SERVICE LETTER

No. 630

Piper Aircraft Corporation

Lubrication of Fuel Valve Selector Mechanism

Service Letter 630

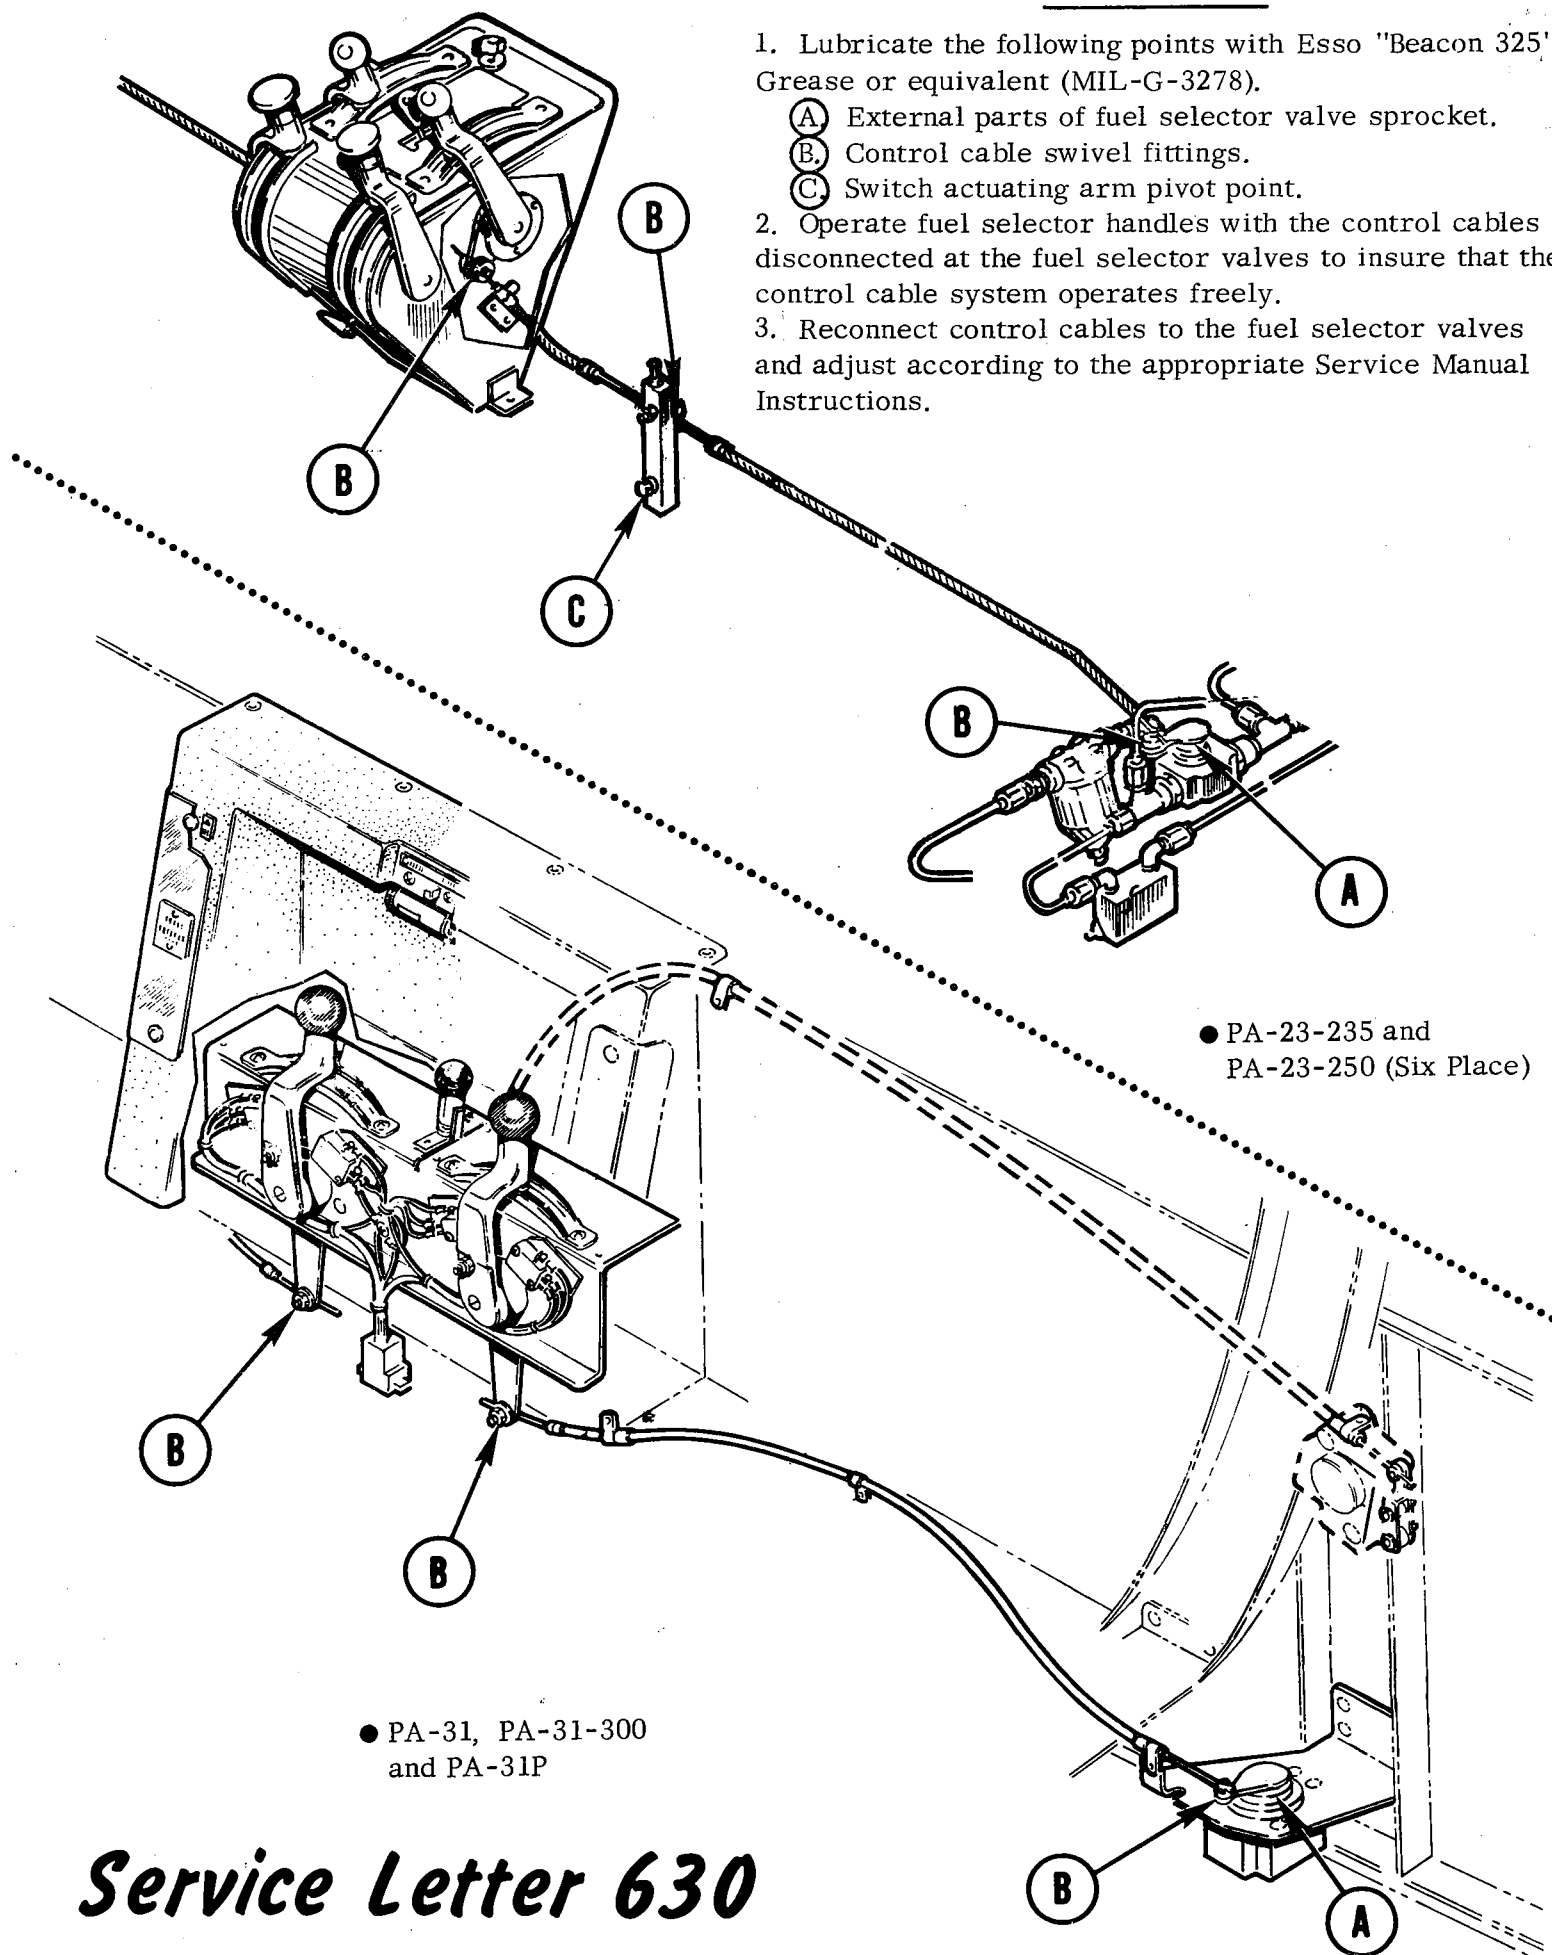
1. Lubricate the following points with Esso "Beacon 325" Grease or equivalent (MIL-G-3278).

- (A) External parts of fuel selector valve sprocket.
- (B) Control cable swivel fittings.
- (C) Switch actuating arm pivot point.

2. Operate fuel selector handles with the control cables disconnected at the fuel selector valves to insure that the control cable system operates freely.

3. Reconnect control cables to the fuel selector valves and adjust according to the appropriate Service Manual Instructions.
